SERVICE BULLETIN

BULLETIN NUMBER: 175

MODEL: Diesel Generators WMD, BCD, BTD up to 12.5 KW and BTDA up to 12.5 KW

SUBJECT: Fuel Solenoid #023041 Circuit Improvement

Illustration of Circuit Breaker and Red Wire Lead
Between the
Preheat Solenoid and Fuel Solenoid

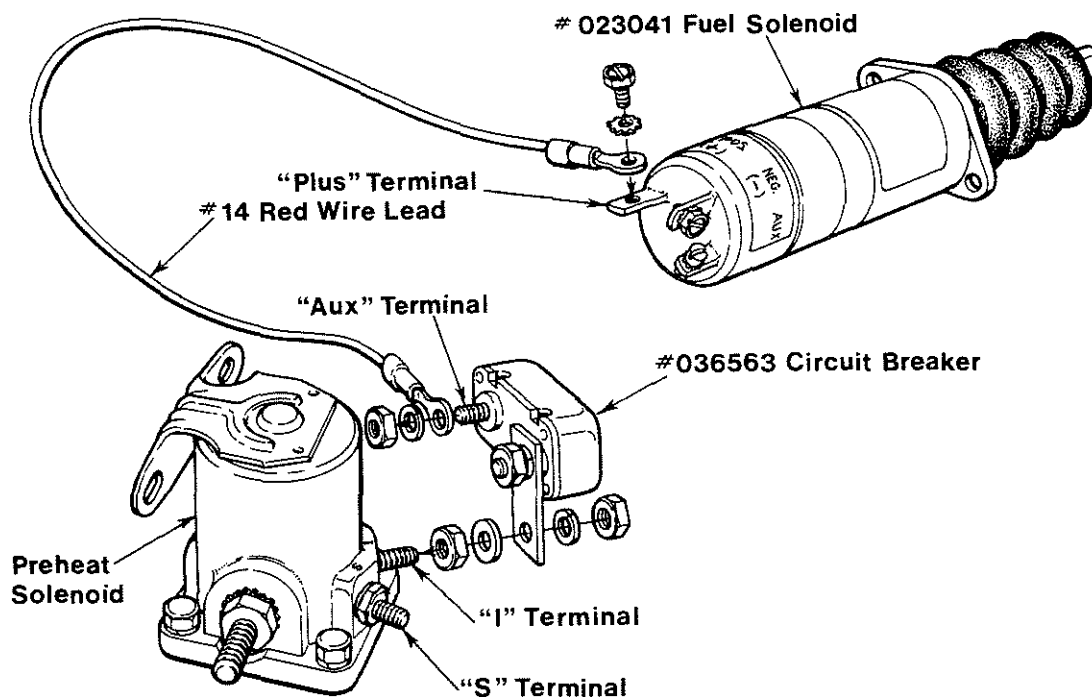
In an effort to prevent fuel solenoid failures that are the result of a voltage loss/reduction in the fuel solenoid circuit during "preheat" and "start," this circuit is now energized using battery voltage available at the "I" terminal on the preheat solenoid when this solenoid is energized during "preheat."

Early model WMD, BCD, BTD and BTDA units up to 12.5 KW can incorporate this circuit by installing circuit breaker assembly #036563 to the vacant "I" terminal of the unit's preheat solenoid and running a #14 red wire from the "aux" terminal of the circuit breaker assembly over to and connecting with the leads presently attached to the "plus" terminal of the fuel solenoid #023041. Ensure this wire is secured and protected against chafing and engine hot areas it passes near.

NOTE: The "I" terminal 10 - 32 threads, circuit breaker connection #10 terminal end for #14 wire, fuel solenoid (plus) terminal #8 terminal end for #14 wire, and #14 wire - length as required.

WIRING DIAGRAM

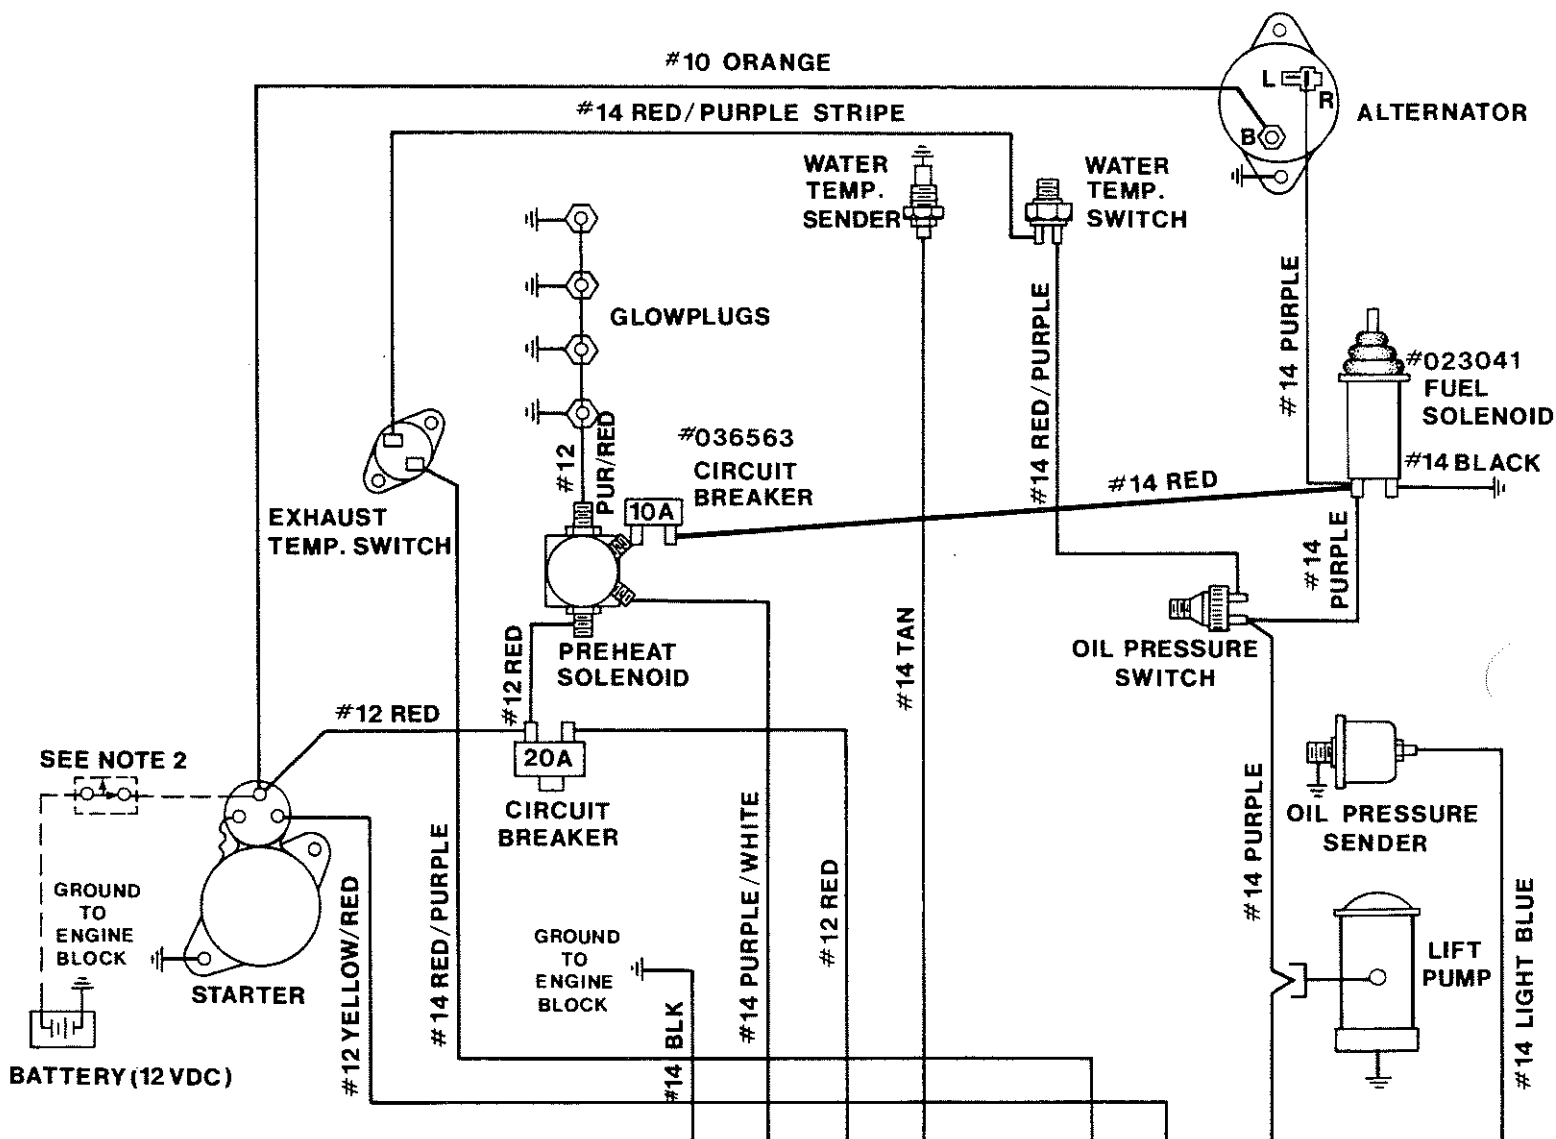
The wiring diagram, on the reverse of this page shows this circuitry being installed on earlier model diesel generators as listed above.
